Mounting DIN components into Teubels meter boxes.

Modifications required to install a ES23 into old Teubels meter boxes. These modifications are required to allow the door to close and MCB's etc to operate correctly.

Without alterations ES23 on the panel showing alterations and the panel moved back.

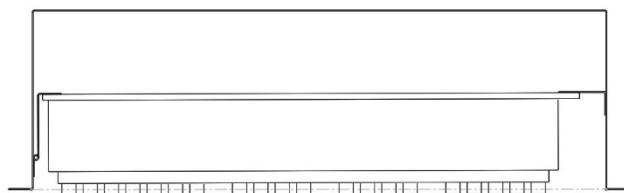
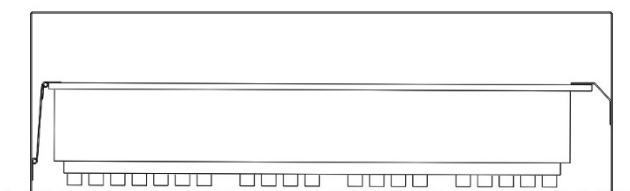
1. The L shaped hinged mounting needs to straightened and a piano hinge add so the panel can be located 8mm deeper into the box.
2. The fix mounting needs to be reshaped as shown. (Long Vice-grips are recommended for this).

Note. These alterations allow the panel location to float and mount to exist mounting points, as well as letting panel to open to over 90 degrees without the components hitting the side of the box.
